THIRD READINGS SUMMARY SHEET

<u>CASE</u>: C814-2023-0057 (200 E. Riverside PUD) <u>DISTRICT</u>: 9

ZONING CHANGE REVIEW SHEET

<u>CASE</u>: C814-2023-0057 (200 E. Riverside PUD) <u>DISTRICT AREA</u>: 9

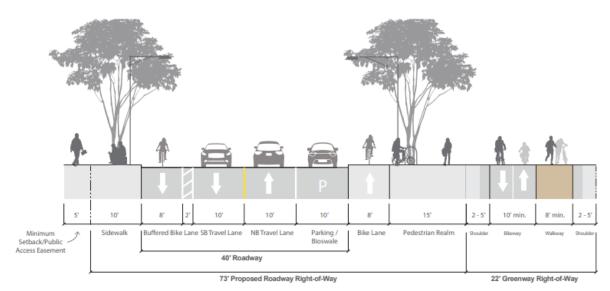
ATD 9. Additional Comments:

17. THE PUD WILL BE FOCUSING ON SIGNIFICANT IMPROVEMENTS FOR PEDESTRIAN AND BICYCLE ACTIVITY FROM EAST RIVERSIDE DRIVE TOWARD LADY BIRD LAKE IN COORDINATION OF PROJECT CONNECT AND AUSTIN TRANSIT PARTNERSHIP. THE IMPROVEMENTS WILL BE ON THE WEST SIDE OF THE PROPERTY WITH CONNECTIVITY TO THE PARKLAND DEDICATION AREA ON THE ADJACENT PROPERTY TO THE NORTH. THE IMPROVEMENTS WILL PROVIDE CLARITY IN BOTH WAYFINDING AND GREATER PEDESTRIAN AND BICYCLE TRAFFIC SAFETY WITH CLEARLY DELINEATED PATHWAYS.

TPW recommends that the PUD specify these improvements by offering deference to the South Central Waterfront Plan, specifically the 22' "greenway" and/or the desired cross-section as identified by Project Connect when available:
